# **Avnet PicoZed 7010/7020 Revision C Errata**

# 1 Introduction

Figure 3 – Extra Caps on PicoZed 7010/7020 Rev C

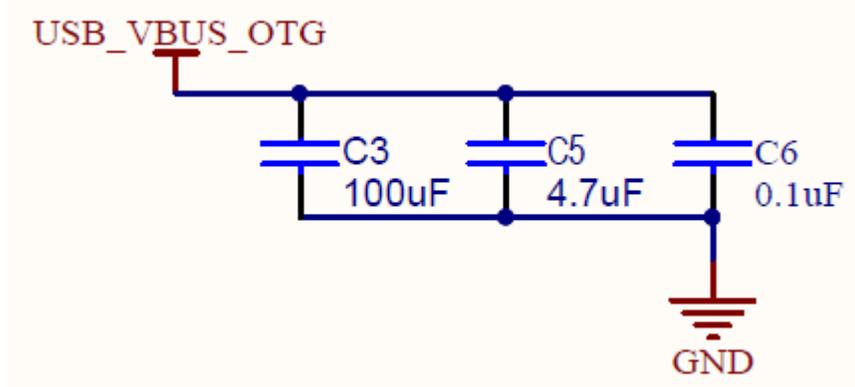
The Microchip USB3320 outlines very specific capacitance guidelines for setting the PHY mode to Host, Device, or OTG. To keep the PicoZed as flexible as possible, the Mode setting capacitors must be placed on the Carrier based on the operating USB mode the user requires. On Rev C, extra bypass capacitors were placed on the JX3 connector that may interfere with this mode setting.

Depopulate C3, C5, and C6 on the SOM.

This fix is implemented on PicoZed 7010/7020 Revision D.
